UNITED STATES PATENT AND TRADEMARK OFFICE

10/563,898

Office Action Summary	Application No. 10/563,898	Applicant(s) BLANGE, JAN-JETTE	
	Examiner MAI T. NGUYEN	Art Unit 3671

DETAILED ACTION

FIGURE A

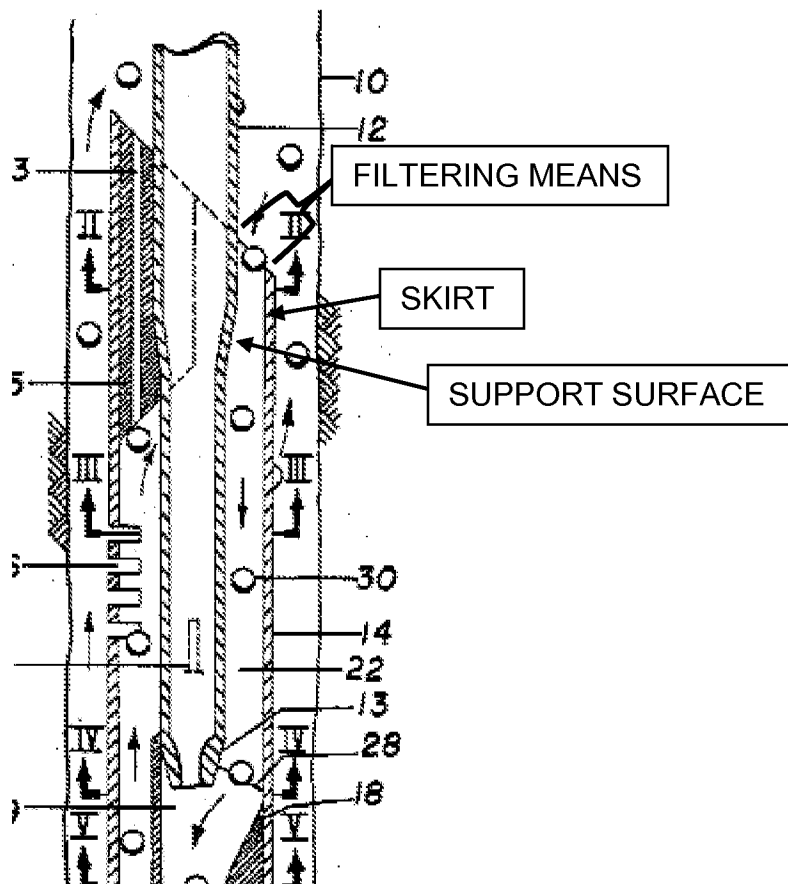
7. a jetting system having a nozzle means 17 arranged to receive a fluid and abrasive particles via an abrasive particle inlet 28, and arranged to impinge the object to be excavated with a jetted stream of the fluid mixed with the abrasive particles; a recirculation system arranged to recirculate at least some of the abrasive particles from a return stream, downstream of impingement of the jetted stream on the object to be excavated, back to the jetting system via the abrasive particle inlet, see column 1, lines 32-35; and a filtering means disposed in a path fluidly connecting the return stream with the abrasive particle inlet 28, wherein the filtering means includes an openings that is

sized to keep the abrasive particle inlet 28 free from objects of the same size or larger than the abrasive particle inlet 28, which filtering means allows passage of the abrasive particles 30, see the following Figure A.

8. Regarding claim 2, Ortloff discloses the filtering means, which is considered the openings between cylindrical members 12 and 14, is shaped or arranged such that the filtering means is impassable for a particle having the same projected size and shape as an entrance window of the abrasive particle inlet 28 and at the same time such that the one or more filter openings cannot be fully blocked by one such a particle, see figure 2.

9. Regarding claims 5 and 12, Ortloff discloses the recirculation system comprises a support surface, considered the outer surface of member 12, to guide the abrasive particles 30 towards the abrasive particle inlet 28, whereby the filtering means are provided in the form of a skirt, considered member 14, creating a filter opening in the form of a slit, considered the opening between members 12 and 14, between the skirt and support surface, see figures 1, 2 and A.
